SUBJECT: W.P. 32-65-00, Site 11-3,  
Papineau Creek Bridge,  
(3.9 miles north of Highway 62),  
Highway 127, District 10-Bancroft

FOUNDATION INVESTIGATION REPORT  
For

The Proposed Crossing at  
Papineau Creek and Proposed  
King's Highway 127 Line 'T'  
Bridge Site 11-3

REVIEW OF DESIGN DRAWINGS:

DESIGN	H.K.J.	CHECK	H.K.J.	DATE	12/1/14
DRAWING	T.B.L.	CHECK	H.K.J.	SITE No.	11-3
DATE	12/1/14	PROJECT	11-3	SHEET	3

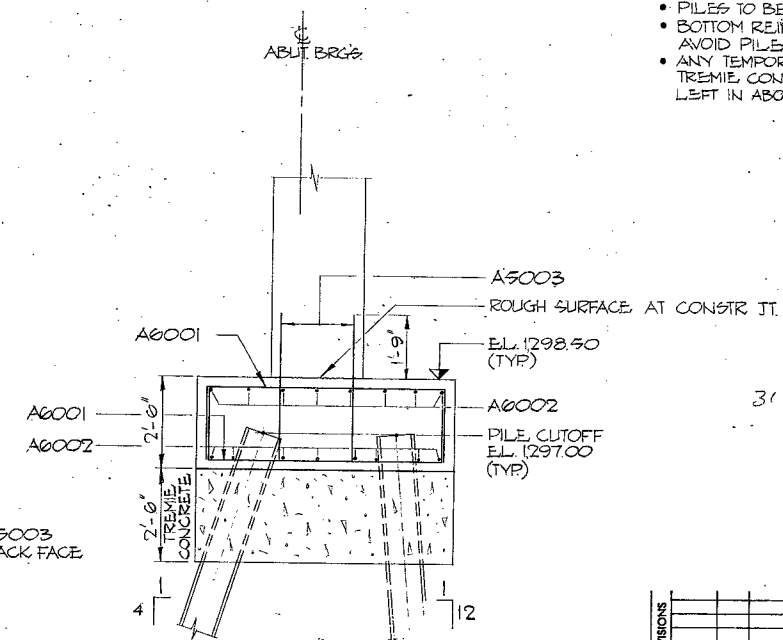
4. Are estimated pile lengths shown on Drawings correct?  
If not, make a new list. PILE LENGTHS SHOWN ARE APPROXIMATELY 2' TOO LONG
5. If excavation of unsuitable soil is recommended, is this shown on Drawings? N/A

8. Summarize your comments; on separate sheet if necessary.
  1. PILE LENGTHS COULD BE REDUCED BY 2' & STILL ALLOW 2' EXTRA FOR DAMAGE TO TOP OF PILE & LOWER ELEV<sup>N</sup> OF BEDROCK THAN PREDICTED.

2. DEWATERING WILL BE REQUIRED TO PREVENT BOILING OF BOTTOM OF EXCAVATION FOR PILE CAPS.
  3. FOUNDATION REPORT RECOMMENDS 25' RIPRAP DOWNSTREAM (ONLY 15' IS SHOWN) FOR SCOUR PROTECTION
